CITY OF VAUGHAN

EXTRACT FROM COUNCIL MEETING MINUTES JANUARY 20, 2015

8. **SIGN VARIANCE APPLICATION**  
**FILE NO: SV.14-013**  
**OWNER: T-STAR CORP.**  
**LOCATION: 1600 LANGSTAFF ROAD**  
**LOT 38, PLAN 65M-2043**  
**WARD 4**  
(Referred)

REFERENCE RE: SIGN VARIANCE ITEM # SV 14-013 – 1600 LANGSTAFF RD

Drawing No.  
PD 140433-A

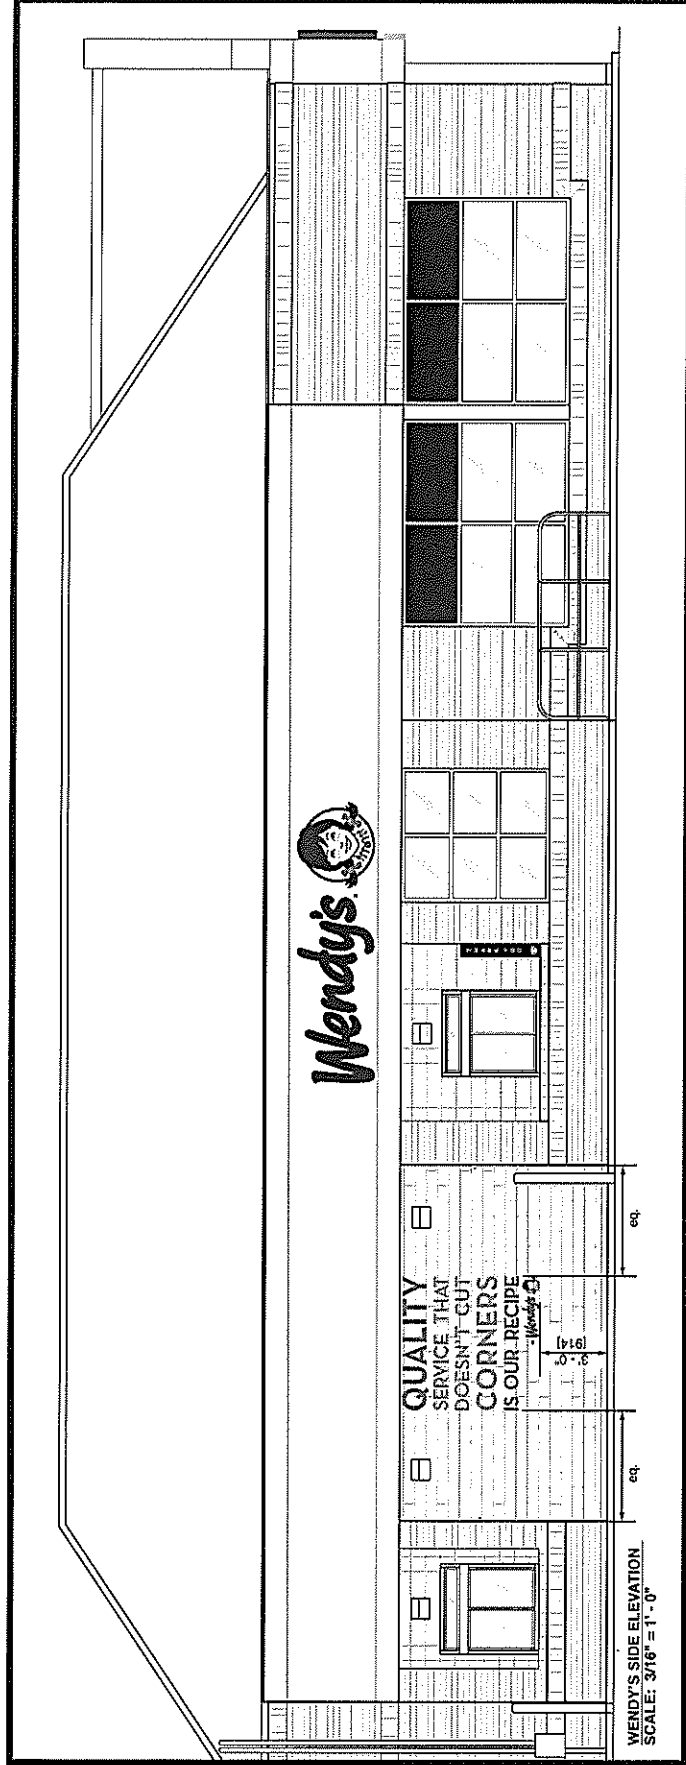
1. That Sign Variance Application SV.14-013, T-Star Corp., be REFUSED.

The Wall elevation would permit a sign up to 20 sq.m. Although the proposed sign and existing wall sign combined is 6.64 sq.m, it does not meet the minimum height requirement of 2.44m above the finished floor level immediately below such sign. In addition, staff have concurred that the support of an additional sign for the purpose of advertising a phrase rather than business identification is unnecessary and creates excessive signage, and would not be keeping with the intent and purpose of the sign bylaw. The applicant currently uses two pylon signs, one wall sign, directional and window signs to assist with conducting their day to day operations.

The various options presented variations upon the same theme, - adding the name Wendy's and/or Wendy's logo to the corporate slogan. This was upon the recommendations of both the Sign Variance Committee as well as the Committee of the Whole. Both Committee's addressed the question on the aspect of identification. It was stated that by adding the Wendy's name and logo, the slogan would be in keeping with the aspect of identification.

To that end, Wendy's World Headquarters reviewed the five options presented to them and selected the option where the slogan is identified with a signature Wendy's name and logo. This was felt to be a balance between the original slogan used nationally and the request of the Sign Variance Committee.

We believe that the proposed modification to the slogan; which would be used only in Vaughan in order to assist in appeasing the concerns with respect to the quantification of identification; addresses the concerns raised by the Sign Variance Committee.

- 1) That the modified design as set out in Communication C2, from Mr. Just Cole, Steel Art Signs, Esna Park Drive, Markham, dated January 19, 2015, be approved; and
- 2) That the report of the Sign Variance Committee, dated January December 2, 2014, be received.

We request that the Council approve the modified slogan design as presented which has been developed with the intent of bridging the concerns previously raised.
